Access Compliance Report

Public Rights-of-Way

Intersection ID: 18769	Main Street: BARCLAY_DOWNS_DR	Cross Street: RUNNYMEDE_LN	Location: NE
ADA ID: 8D2DE9981833	Ramp Type: Perp	Initial Pass/Fail: Fail	Overall Compliance: No
			Severity Score: 13.75

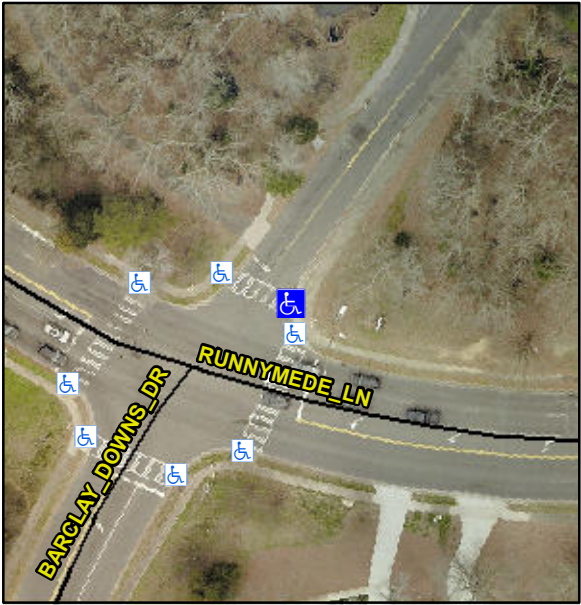
Codes/Mitigation Info/Possible Solution			Field Measurements/Component Compliance		
	Possible Solutions:		Compliance	Description	Data
	Remove & Replace Entire Ramp.		No	Ramp Length (in)	109.0
			Yes	Ramp Width (in)	75.0
			N/A	Flare Type LT	N/A
			N/A	Flare Slope LT (%)	N/A
			N/A	Flare Traversable LT?	N/A
			N/A	Landing Length (in)	N/A
			N/A	Landing Width (in)	N/A
			N/A	Landing Slope (%)	N/A
			N/A	Landing X Slope (%)	N/A
<p>Surveyor Notes:</p> <p>N/A</p> <p>PROW/ADA:</p> <p>Not Found, R304.2.2, R304.5.3</p>			N/A	Flare Type RT	N/A
			N/A	Flare Slope RT (%)	N/A
			N/A	Flare Traversable RT?	N/A
			N/A	DWS Provided?	N/A
			N/A	DWS Contrast?	N/A
			N/A	DWS Length (in)	N/A
			N/A	DWS Full Width?	N/A
			N/A	DWS Offset (in)	N/A
			N/A	Gutter Ponding?	N/A
			N/A	Gutter Lip Ht (in)	N/A
			N/A	Painted X Walk1?	Yes
				X Walk 1 Direction	To NW
			N/A	X Walk 1 Width (in)	116.0
				X Walk 1 Slope (%)	4.2
				X Walk 1 X Slope (%)	0.5

N/A	Ramp inside XWalk1?	Yes
			N/A	Road Slope (%)	N/A
			N/A	Road X Slope (%)	N/A
			N/A	Any Obstructions?	N/A
				Obstruction Type	
Total Cost:					
		\$ 1850.00			
			N/A	Clear Space?	N/A
			N/A	Clear Space to XWalk (in)	N/A
			N/A	Storm Grate/Utility Hazard?	N/A
				Storm Grate/Utility Type	
			N/A		N/A
			Yes	Surface Condition? (G/P)	Good
